# MEMORANDUM

**To:** Planning Commission  
**From:** Community Development Department  
**Subject:** Willow View Cove No. 4 Subdivision (Prelim Review) SUB-05-18-5380  
 3 New Lots (5 Lots total) 2.5 Acres  
 Approx. 1630 East 10900 South R-1-20A Zone  
 Community #22

## READY-FOR-PLANNING-COMMISSION MEMORANDUM

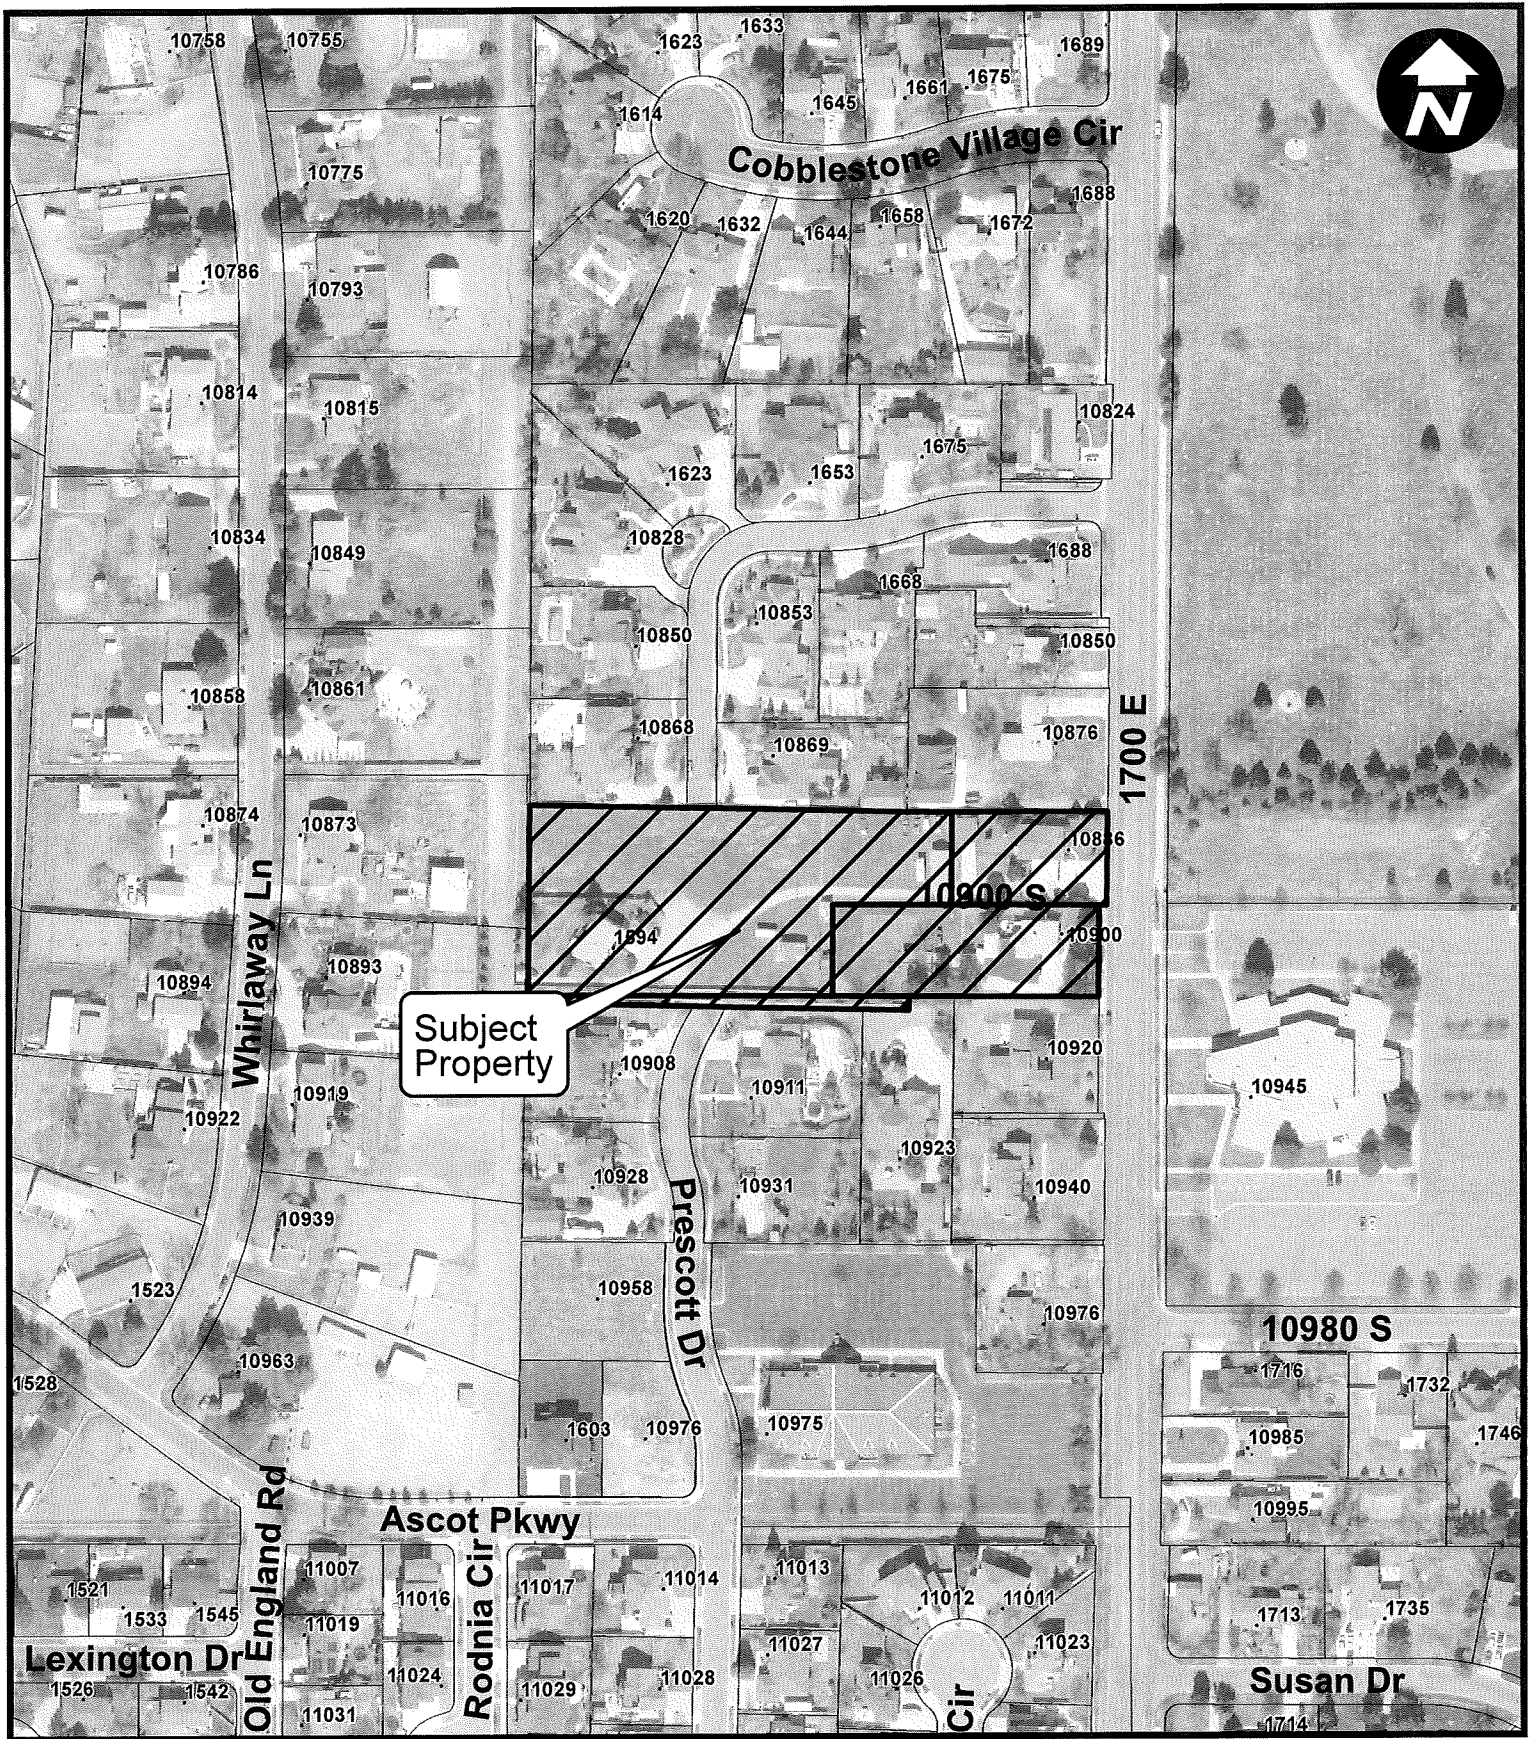
1. Clarification of Property Lines and Existing Fences. There is some dispute over the boundary lines of the subdivision and the existing fence locations. This will need to be resolved prior to recording. The fence locations and subdivision boundaries need to be aligned to avoid confusion and further dispute over ownership and maintenance responsibilities.

2. Maintenance of Sidewalk. Staff would suggest that the applicant either create a new homeowner's association to ensure maintenance of the private sidewalk or join the existing HOA of the other phases of Willow View Cove. Staff would prefer the latter option to ensure that the HOA is of significant size and scale to manage the common responsibility.

3. Lot Line Adjustments. Two (2) lot line adjustments need to be recorded in connection with this subdivision proposal. There is a remnant parcel that needs to be resolved near the northwest corner of the subdivision. The Wilding parcel was altered to include some of that parcel area with the proposed subdivision. This needs to be formally approved by Sandy City before this proposed subdivision can be approved.

1. That public street improvements be carried out in accordance with plans and profiles stamped and approved by the Sandy City Public Works Department, and specifically:
  - a. That Prescott Drive be dedicated as a thirty-two foot (32') public right-of-way and improve the street to City Standards.
  - b. A new five-foot (5') meandering sidewalk be installed along both sides of Prescott Drive. The developer is required to dedicate a fifteen-foot (15') Parkway Sidewalk and Public Utility Easement to allow for public access to the sidewalk. That the sidewalk be maintained privately by the homeowners association.

5. That all residential lots comply will all requirements of the R-1-20A zone.
6. That the developer relocate existing fences or install a new six-foot (6') solid opaque perimeter fence along the boundaries of the subdivision. Said fence shall conform to development code requirements, especially as it pertains to front yard areas.

7. That the necessary lot line adjustments be recorded prior to the recording of the plat.
